December 19, 2014

Re: SR 99: Shaft Excavation Status Report & Action Items for Discussion
TBM Access Shaft, Seattle, WA

Figure 1: West Shaft Wall Design In-Fill Areas (Solid Gray Shaded Areas)

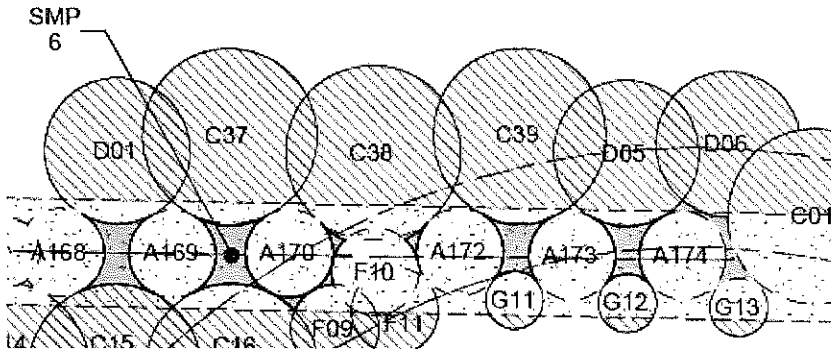
Reviewing the as-built locations of the shaft piles at regular vertical intervals, we are concerned that there is a potential for much larger untreated soil zones to exist that were not considered in the design, depending on the location of the SESMP piles. The design pile layouts shown in Figure 1 and Figure 2 indicate the originally expected in-fill or void areas in solid gray.

Figure 3: West Shaft Wall Pile As-built (Potential Void Areas Highlighted in Yellow or Hatched)

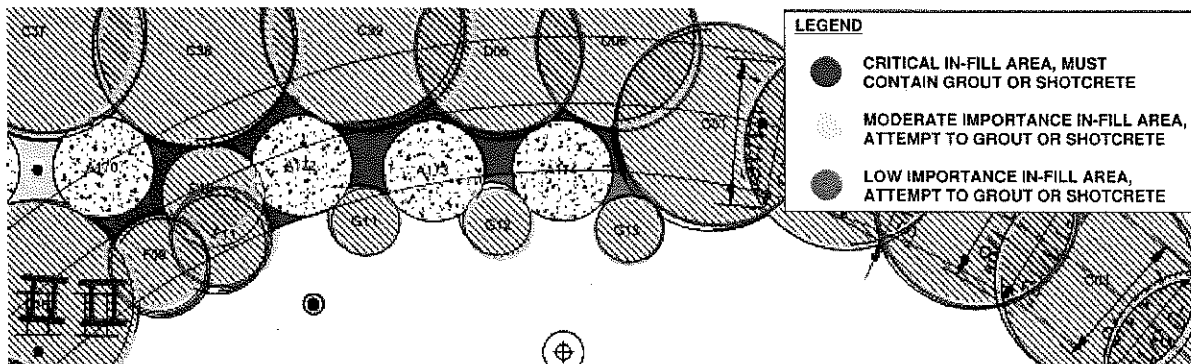
Upon review of the as-built secant pile locations with respect to the SESMP piles, there appears to be a potential for much larger in-fill areas than initially intended in the design. Given the observed untreated soil zones in the in-fill areas to date, the as-built pile layouts shown in Figure 3 and Figure 4 indicate the extent of potential untreated zones in the colored areas. Potentially untreated soil zones that fall within the theoretical design compression ring and may have a significant effect on the stability of the shaft structure are shaded red. A continuous compression ring of adequate thickness and strength is essential for the structural stability of the wall.

While it is likely the in-fill areas are larger than initially intended, we do not believe they are as extensive as shown in the as-built pile layouts of Figure 3 and Figure 4. For example, Figure 4 shows the potential for a nearly continuous void through the entire width of the shaft wall between piles B177/F06 and B178/D18. However, if this were the case, we believe that significant seepage and ground loss would have been observed during the course of excavation to date. Given the rate of seepage observed and the lack of ground loss outside the shaft, it is likely there is some continuous wall present between piles B177/F06 and B178/D18.

The source of the uncertainty for the as-built condition is the lack of as-built data for the SESMP piles. Once the as-built of the SESMP piles is incorporated into the existing overall shaft as-built drawings, a more refined analysis of the ring-structure can be completed and critical in-fill repair locations identified.
